Addendum# 2: Final Q&A

Questions Received after May 21st, 2026

OXFORD
SENIOR
CITIZENS
ACTIVITY
CENTER

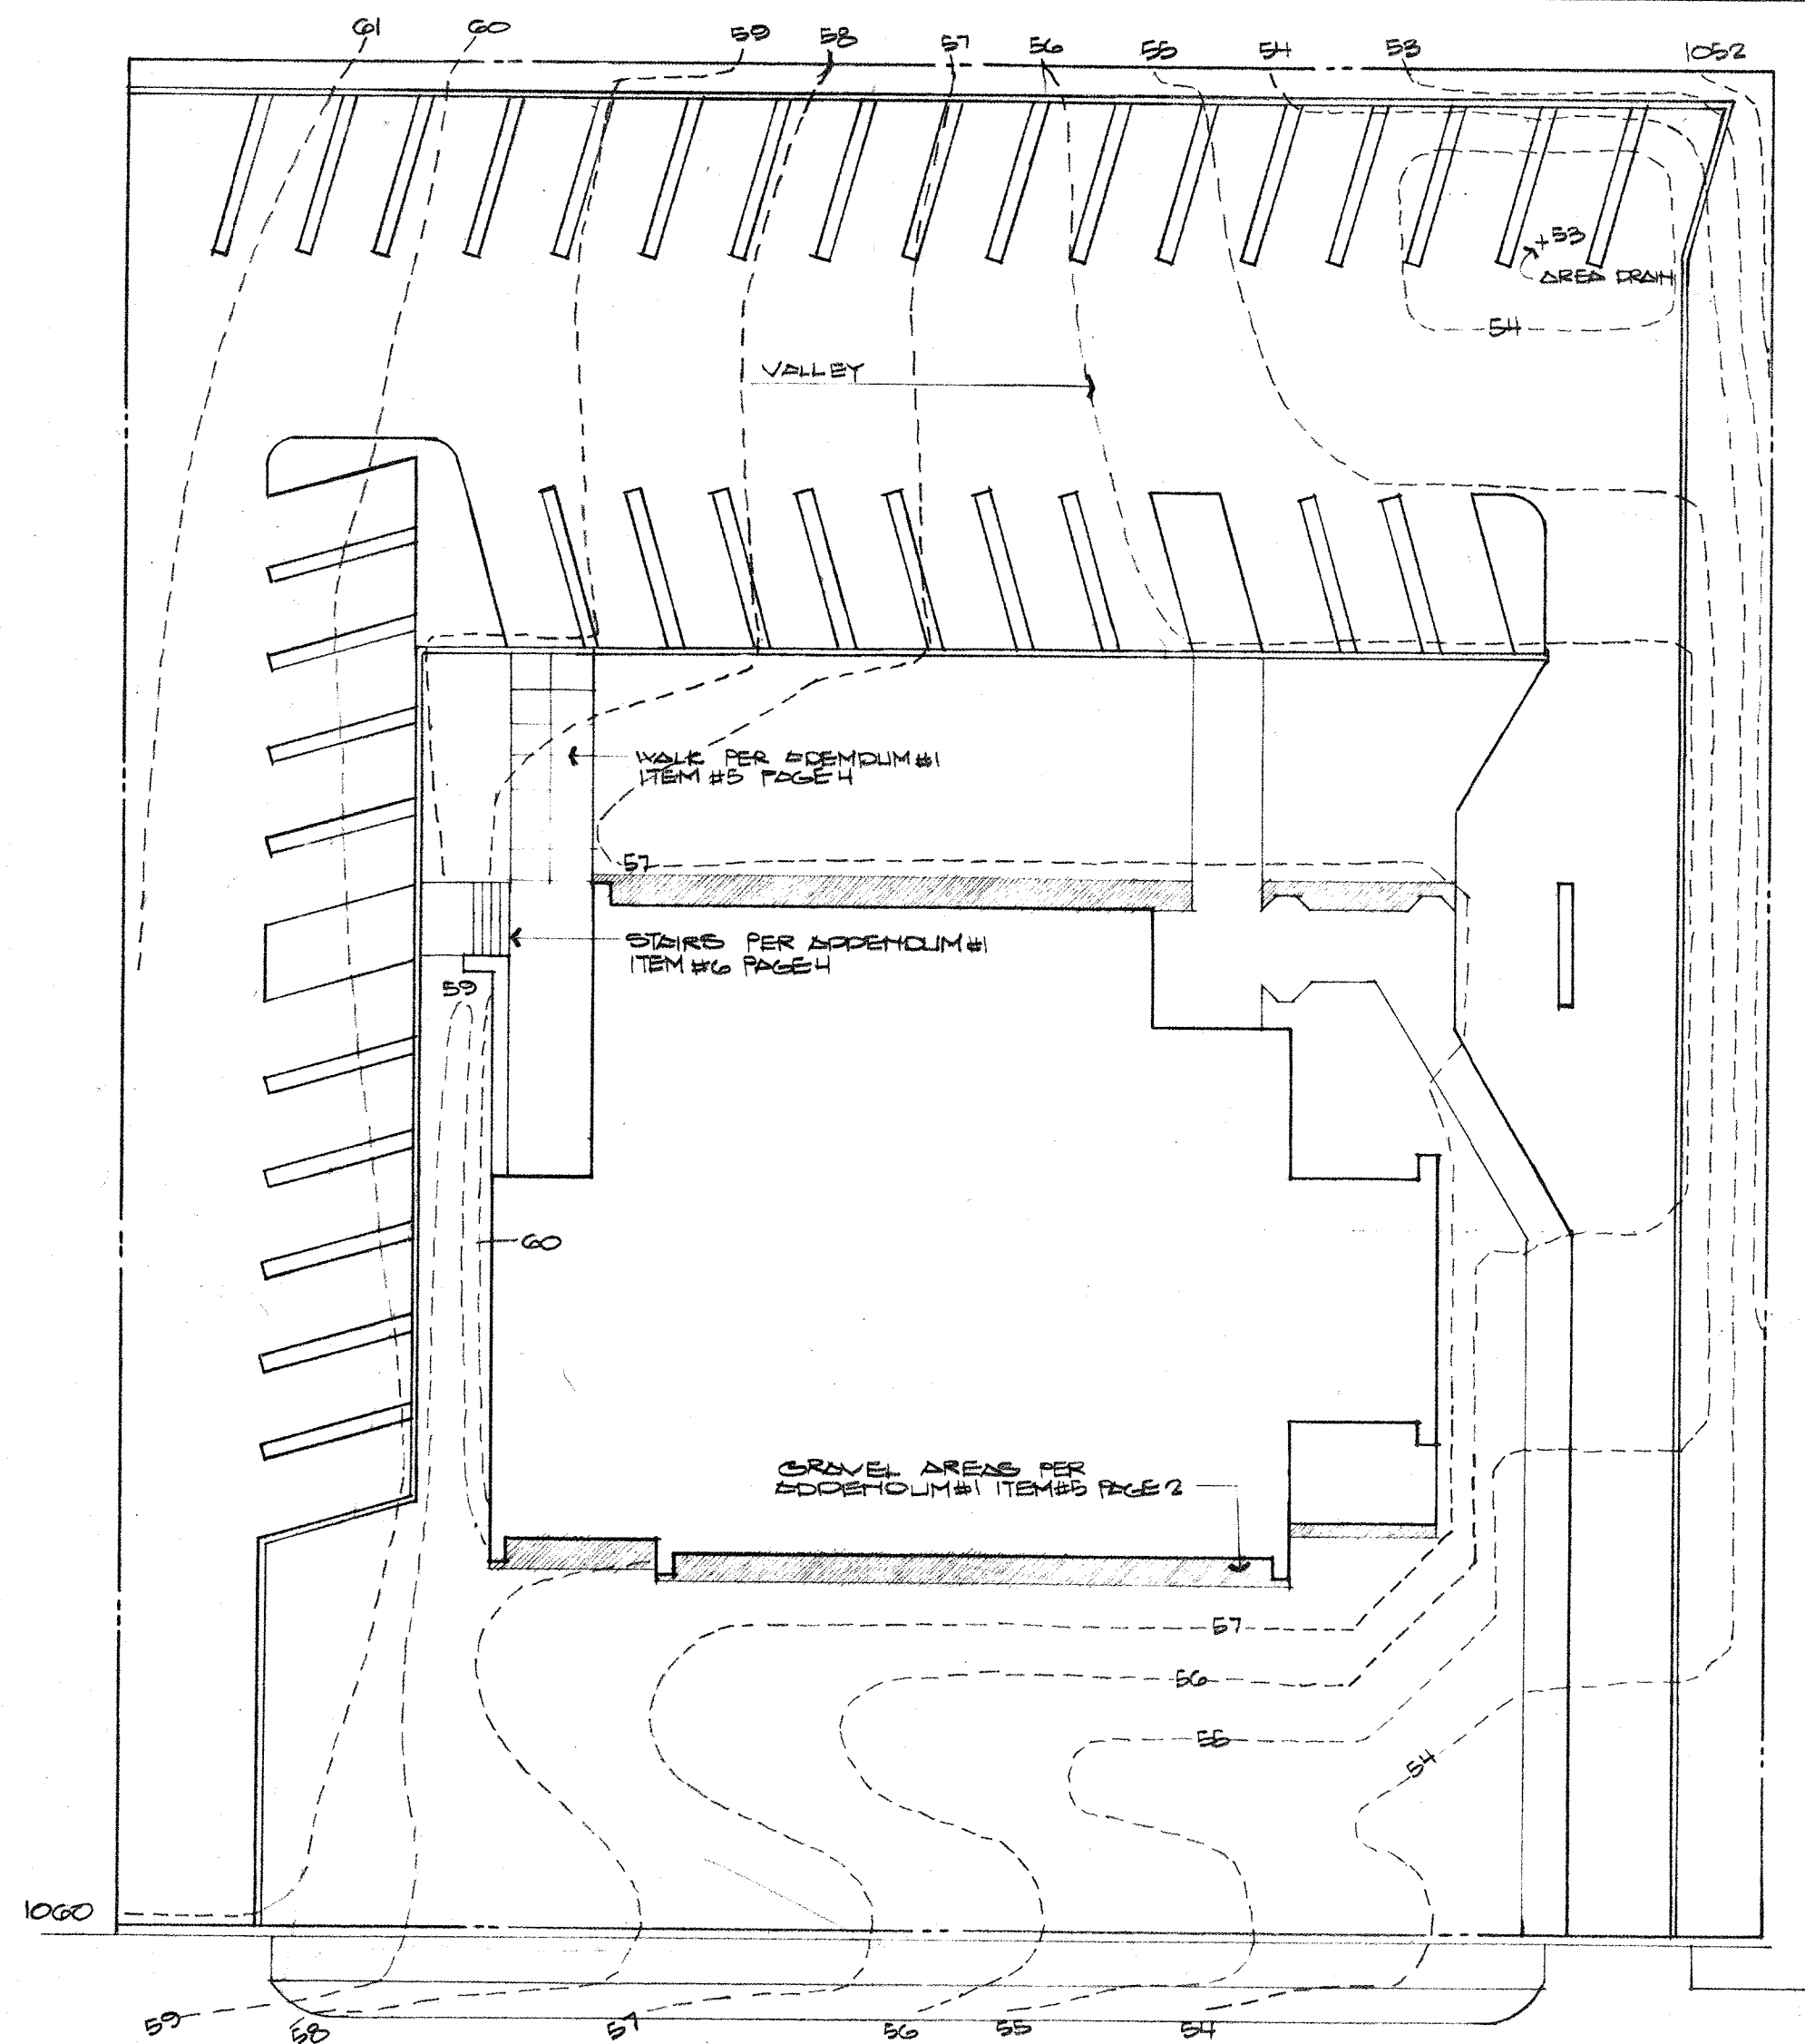
Q: Can the City provide close up photos of the electrical panel?

A: See below.
